METHOD OF MANUFACTURING A SEMICONDUCTOR INTEGRATED CIRCUIT USING A SELECTIVE DISPOSABLE SPACER TECHNIQUE AND SEMICONDUCTOR INTEGRATED CIRCUIT MANUFACTURED THEREBY

Attorney Docket No. 8750-057/Application No. 10/773,805

Annotated Sheet Showing Changes

FIG. 14A

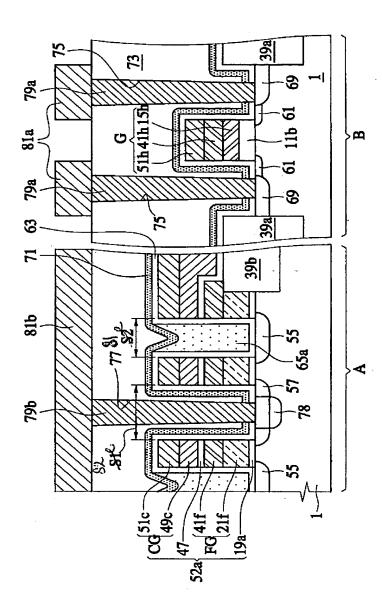
The drawings filed on February 5, 2004 are objected to by the Examiner under 37 CFR 1.83(a).

In view of the drawing corrections described above, applicant disagrees with the Examiner's reason for the drawing objection.

Figure 14A is being amended to correct a typographical error regarding reference numerals "S1" and "S2". The drawing is amended to respectively interchange these numerals. In other words, "S1" is replaced with "S2", and "S2" is replaced with "S1".

Figure 14A has been amended to correct a typographical error regarding reference numerals "S1" and "S2". The drawing is amended to respectively interchange these numerals. In other words, "S1" is replaced with "S2", and "S2" is replaced with "S1".
